UNITED STATES PATENT AND TRADEMARK OFFICE

APPLICATION NO.	FILING DATE	FIRST NAMED INVENTOR	ATTORNEY DOCKET NO.	CONFIRMATION NO.
10/826,311	04/19/2004	Thorsten Stabel	47481-0008-00-US	1320

Office Action Summary	Application No. 10/826,311	Applicant(s) STABEL ET AL.	
	Examiner Sara Addisu	Art Unit 3722

DETAILED ACTION

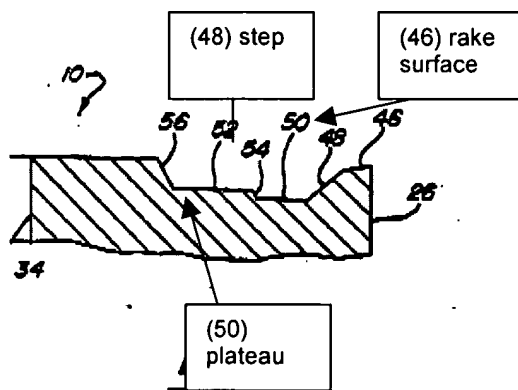
linear when viewed perpendicular to the cutting surface). Additionally, Katbi et al. teaches side flanks forming obtuse corners (see figure 2). Katbi et al. also teaches in figure 3, lateral cutting edge (38) having a sagging middle portion therefore the step is of varying height having a maximum height is disposed at the corner step portions and a minimum height midway between the adjacent corners (refer to the explanation and figure below regarding the varying height of the step: see argument under Response to Arguments). Regarding claim 19, Katbi et al. teaches variable width land surface (rake) which is changes width at (44) leading to a wavy step portion around the corners (see figure 2 and Col. 2, lines 49-54). Furthermore, Examiner points out that Katbi et al. teaches the cutting edge (38: which is arched) has a descending rake (46) located rearward from the cutting edge and the descending rake face is followed by a descending step (48) ('591, figure 4 and Col. 2, lines 45-58 and 66-68). If the height of the step was constant then the step would no longer be descending towards the center of the insert but rather ascending since the rake surface just forward of it has a variable descending angle. See figure below for further explanation (the angles are exaggerated). Katbi et al. teaches the rake face (46) having descending angle 14 degrees and narrower width (wa) at the corner and 12 degrees and a wider width (wb) towards the flank ('591, Col. 2, lines 58-60 and 51-53). As shown below, the left figure indicates corner portion where the cutting edge is at it's highest height (because it's arched at the center), however the rake face has a wider descending angle and a narrower width (wa) which leads to the following portion (i.e. descending step, 48) to start descending from a higher location to plateau 50. On the other hand, the right hand

figure represents the flank area such as the center where the cutting edge is at its lowest height (because it's arched at the center), however the rake face has a smaller descending angle and a wider width (wb) which leads to the following portion (i.e. descending step, 48) to start descending from a lower location to plateau 50, thus there is a height difference (ha is higher than hb) (i.e. the step has a varying height, wherein a maximum height is disposed at the corner step portions, as recited in claim 1).

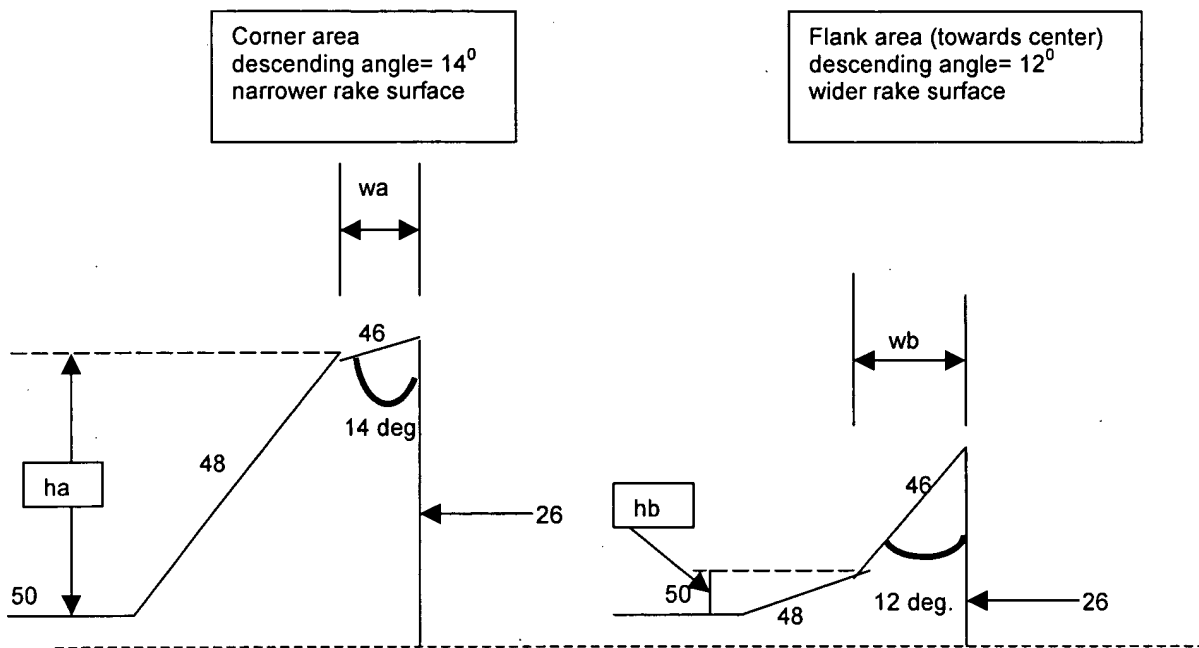
Furthermore, Katbi et al. teaches '591, Col. 2, lines 60-65) that "Those skilled in the art recognize that any angles can be used as the first variable descending land angle so long as the first variable descending land angles at the corners of the insert are greater than the first variable descending land angle of the surface along the flanks of the insert", therefore the selected angles would determine how substantially height difference there should be. Examiner points out that given the fact that inserts are small in size, even if the angle difference is small, there is a height difference which may be considered "substantial" in a unit of measure such as micrometer.

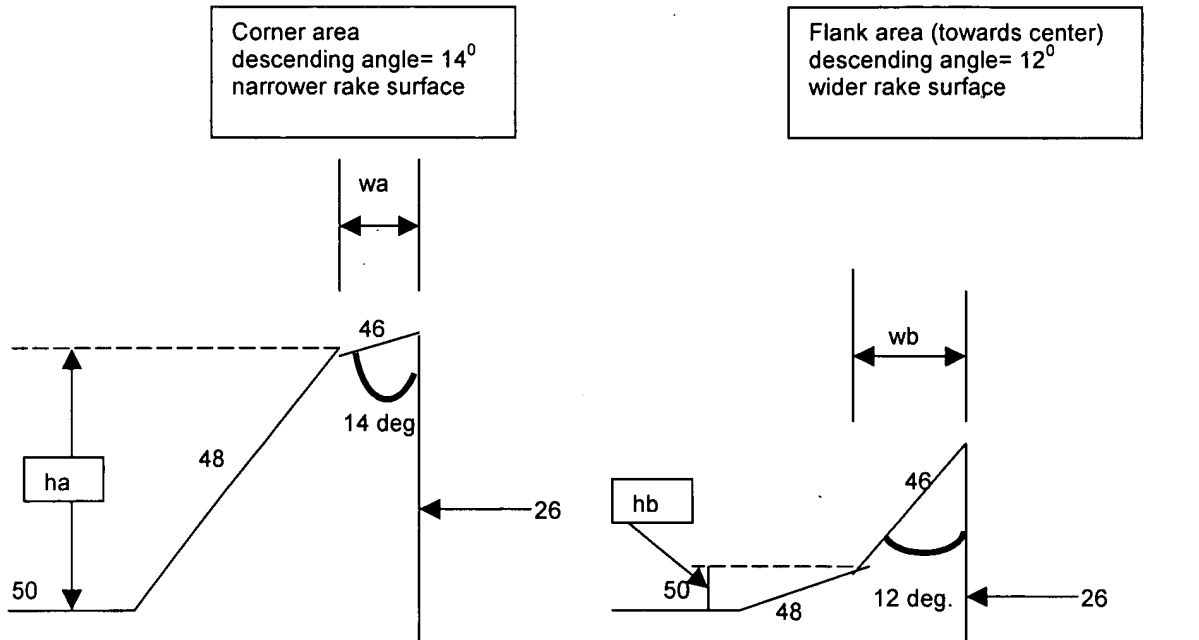
In response to Applicant's argument (page 9, lines 7-14) that "The variable descending land angle 46 is 14 degrees at each corner of the insert and merges to a 12 degree along the flank of the insert.....Applicant respectfully submit that any such variation of the height of step 48 is negligible, and in any event the height of step 48 at the corners is certainly not substantially greater in height of step 48 of the flanks". Examiner respectfully points out that Applicant has not defined what determines the limitation "substantially greater". Applicant has not provided any range to define this difference in height. Broadly reading the claim, Examiner points out that given the fact that inserts are small in size, even if the angle difference is small, there is a height difference which may be considered "substantial" in a unit of measure such as micrometer. Furthermore, Katbi et al. teaches (Col. 2, lines 60-65) that "Those skilled in the art recognize that any angles can be used as the first variable descending land angle so long as the first variable descending land angles at the corners of the insert are greater than the first variable descending land angle of the surface along the flanks of the insert".

In response to Applicant's argument (page 9, line 20 through page 10, line 2) that "...Katbi does not disclose a step. Katbi discloses a descending land angle 46 and a second descending land angle 48. As illustrated in Fig 4 of Katbi, descending land angle 46 and descending land angle 48 are ramps, rather than steps", Examiner submits that MSN Encarta defines "step" as "raised surface: a raised surface for the foot, especially in a series going up or down", therefore, the descending 46 & 48 qualify as a step.

In response to Applicant's argument (page 10, lines 14-18), that "Also the applicant disagrees with the Office Action's position that surface 50 is a completely plain and even surface. Referring to Fig 1 of Katbi, land 48 is a strip of constant width..... Obviously, surface 50 is curved the same way as are the cutting edges 30, 32 and so forth", Examiner respectfully asks Applicant where this is claimed in the instant application as well as where the Office Actions takes this position. Nonetheless, figure 4 indicates that 50 is plain and even. Even if 50 is curves the same way as the cutting edge, as stated by the Applicant, it would be curved from the plan view and not from a side view).
